Access Compliance Report

Public Rights-of-Way

Intersection ID: 13865	Main Street: CENTRAL_AV	Cross Street: TIMBER_HOLLOW_DR	Location: NW
ADA ID: 4CA8BBC485A8	Ramp Type: Combination1	Initial Pass/Fail: Fail	Overall Compliance: No
		Severity Score: 22.5

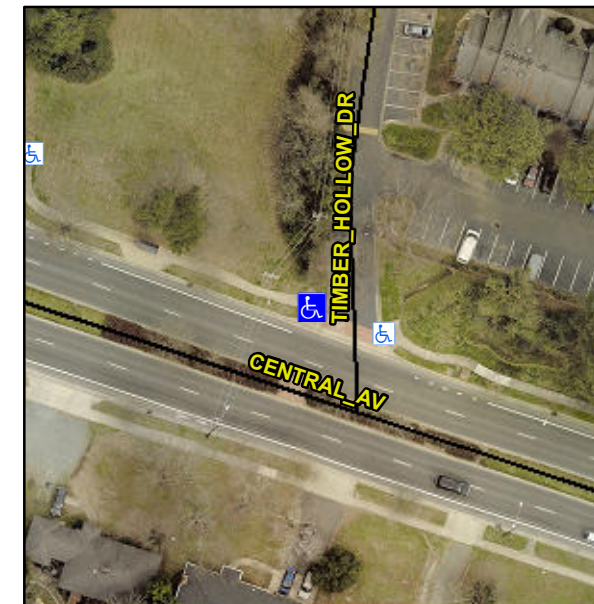
LT RP < 5%

Not Found, R304.5.1, R304.5.3, R304.3.2

Remove & Replace Entire Ramp.
